# Service Bulletin

Conversion from ICAO Annex 16 noise compliance (2500 RPM, full throttle take off power) to FAR 36 noise compliance (2700 RPM, full throttle take off power).

Document: Service Bulletin SB-GA8-2005-10

Figure 1 – Pitch gate attachment

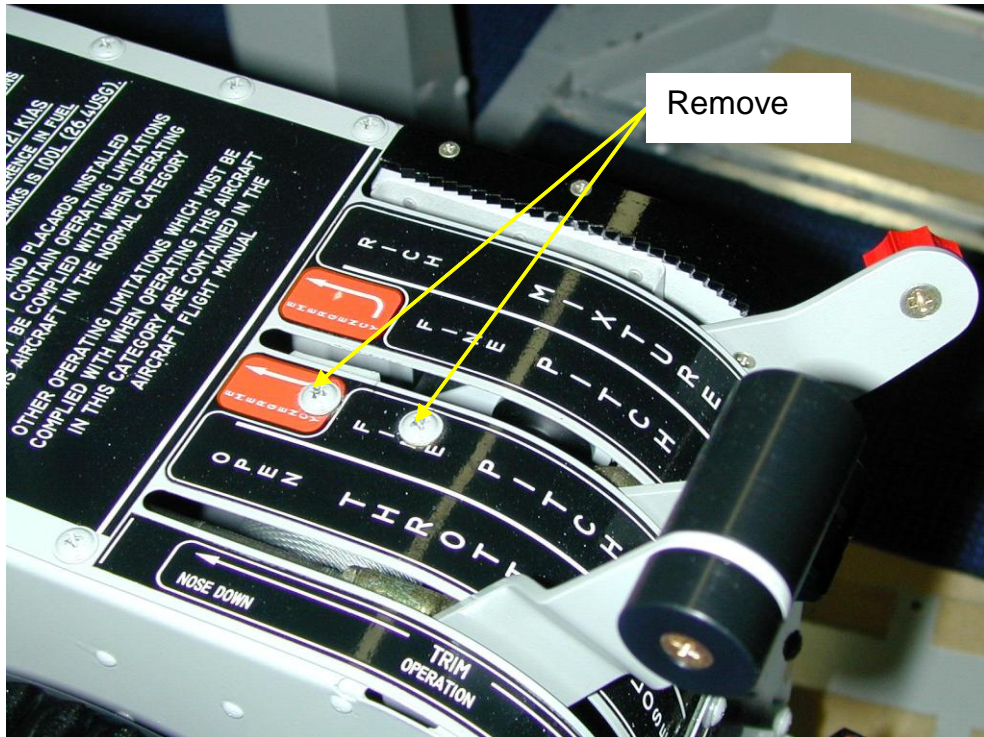
1. Gain access to the throttle quadrant by removing the access panel on the left hand side of the centre console.
2. Unfasten the two screws attaching the pitch stop and backing plate to the throttle quadrant cover. Discard these parts.
3. Replace access panel.
4. Remove throttle quadrant placards and replace with new placards (P/N GA8-112011-329 and GA8-112011-331) per Figure 2.

Figure 3 – Tachometer marking

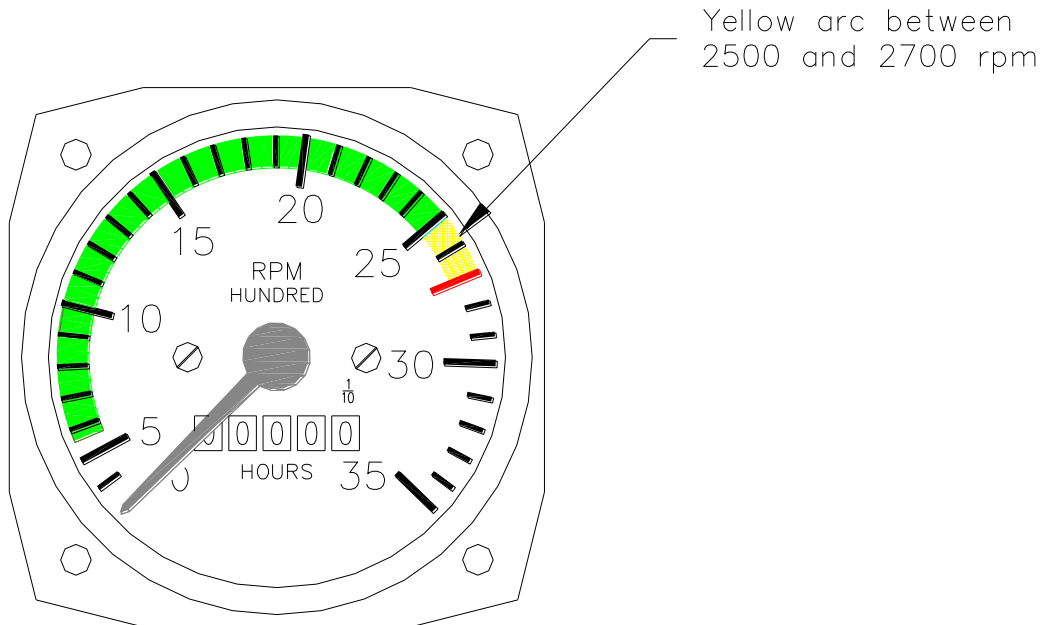
Alternatively, the existing tachometer may be reworked by re-marking the existing red arc between 2500 rpm and 2700 rpm with a yellow arc. Refer to Figure 3. Re-identify the tachometer as GA8-771013-9.
